ADDENDUM NO. 1

SUBJECT: Solicitation No. X009A

TITLE: Miami-Opa Locka Executive Airport (OPF) Runway 09L-27R Rehabilitation

SHEET NO.	ED-10
CADD FILE NO.	2107C1UN.DWG

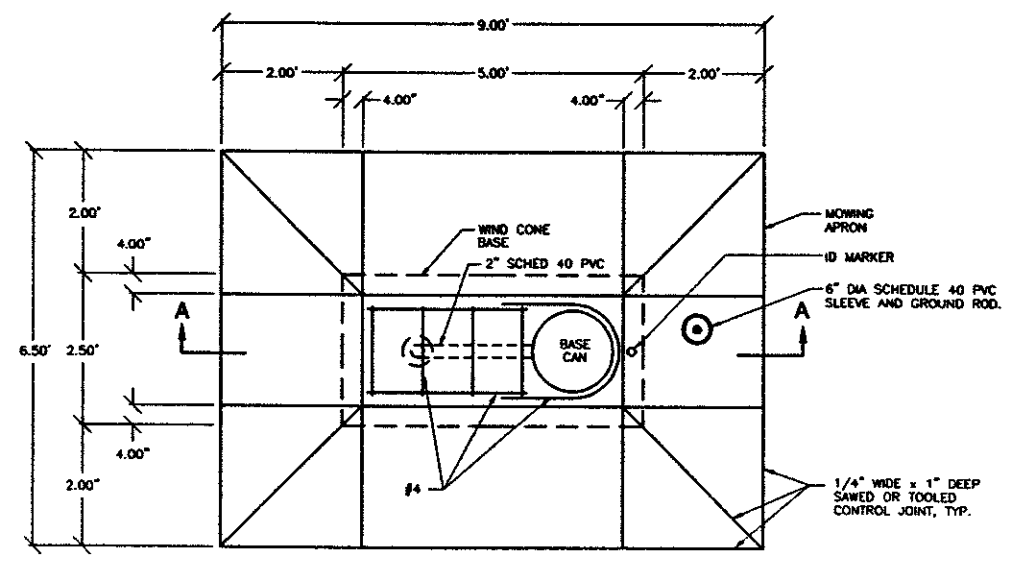
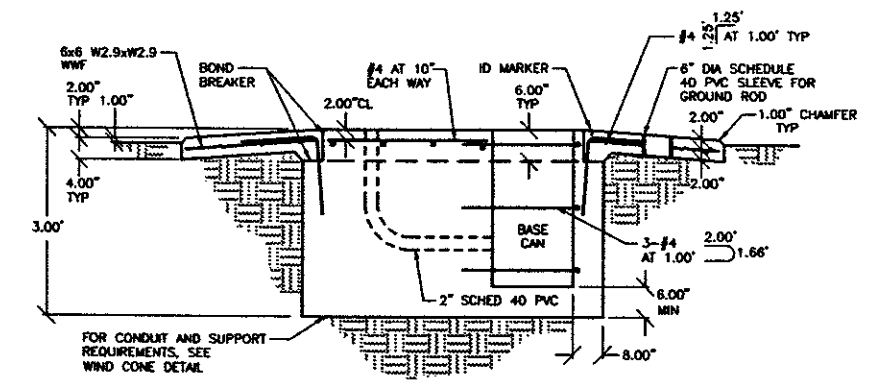
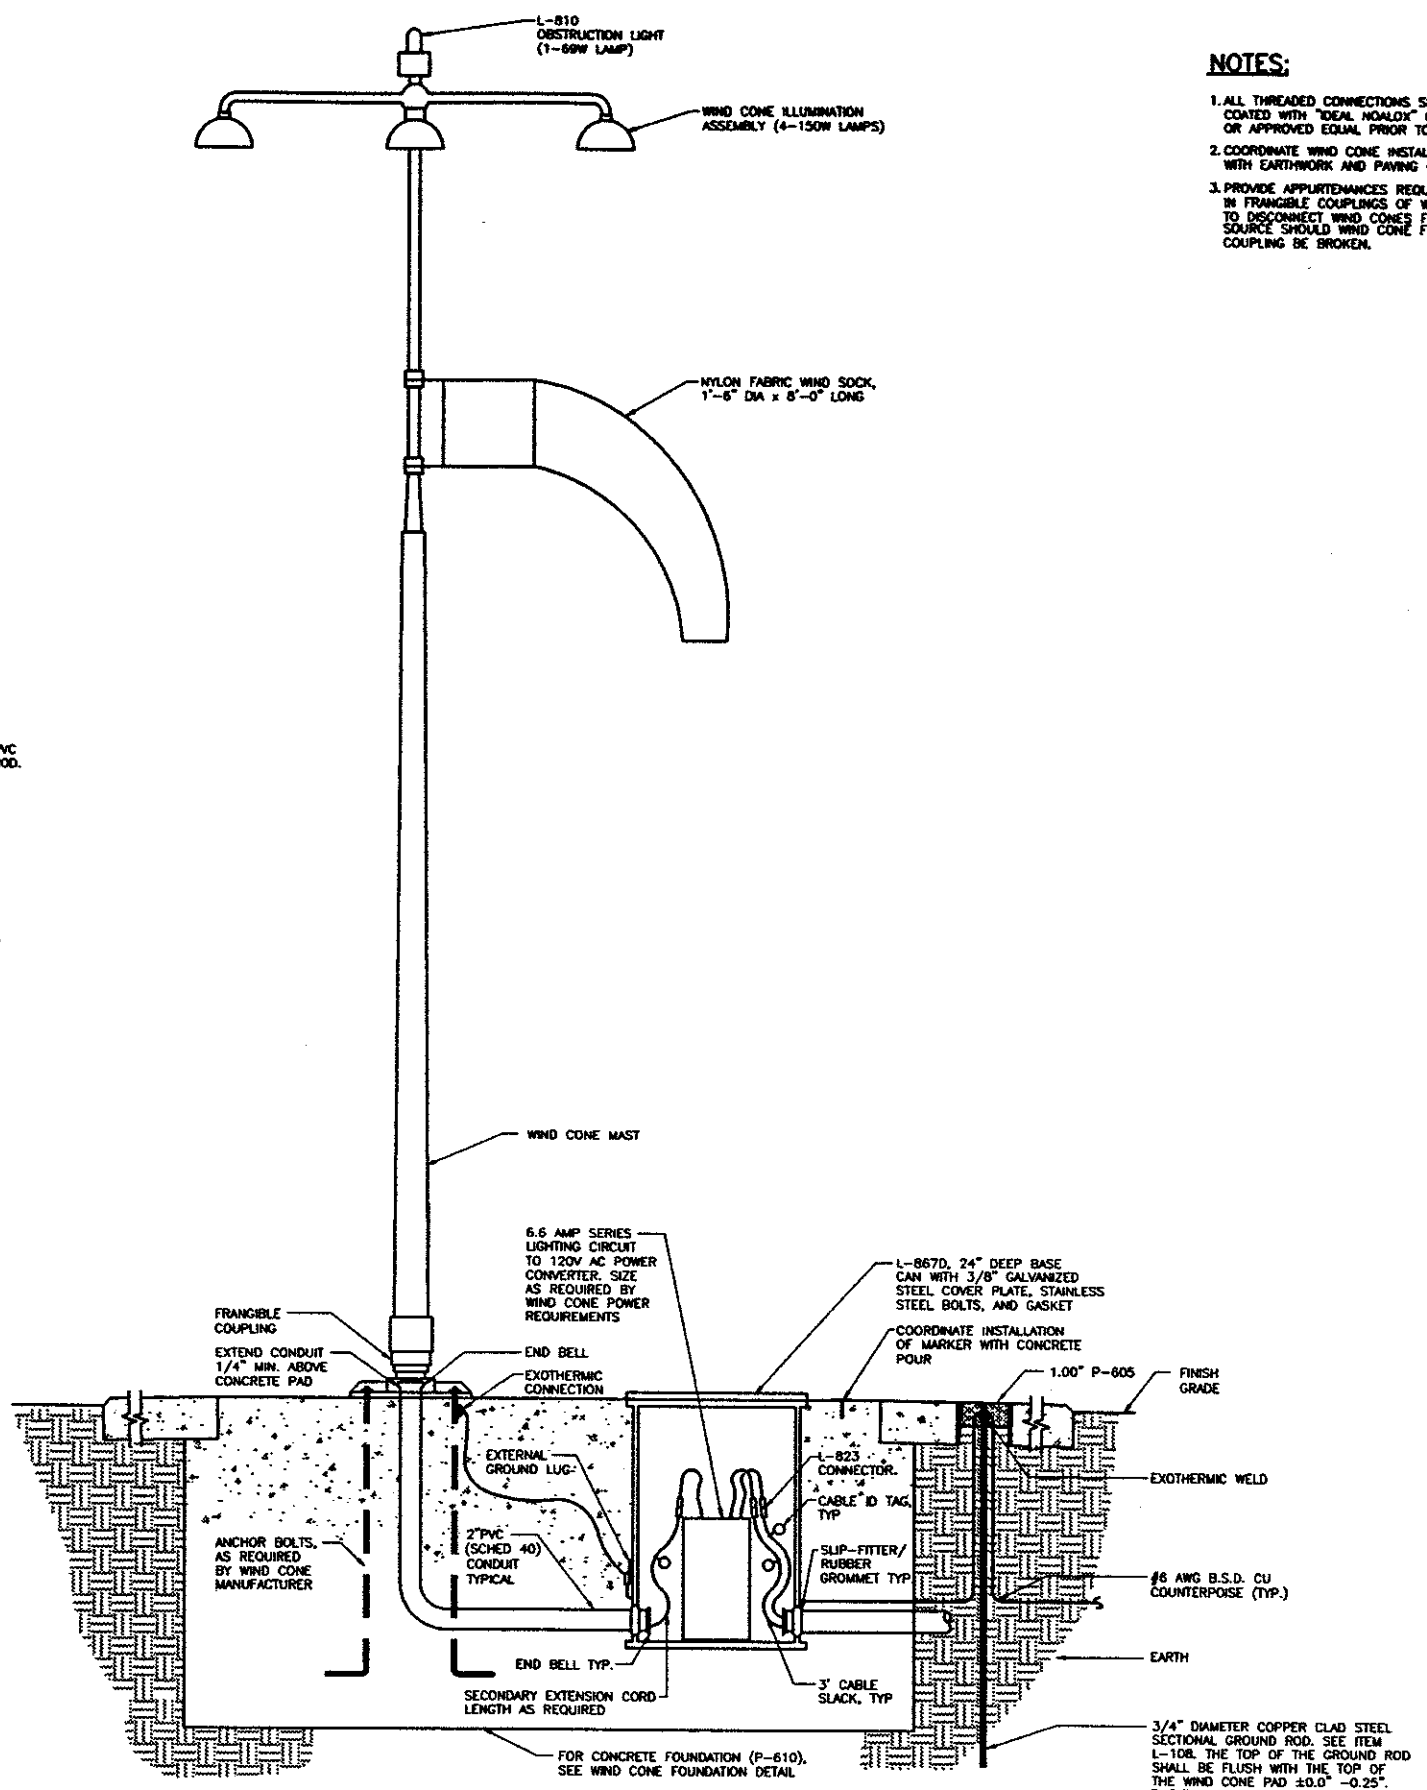
Question No. 75 Bid Item 66 and DWG N-107 – Please provide a detail and scope of work for the wind cone relocation.

Answer No. 75 Bid Item Note on Sheet N107 details the reuse of existing wind cone at new location and scope of work. Refer to Attachment 4 of Addendum No. 1, Construction Plans & Drawings – Revised, Sheet ED-10
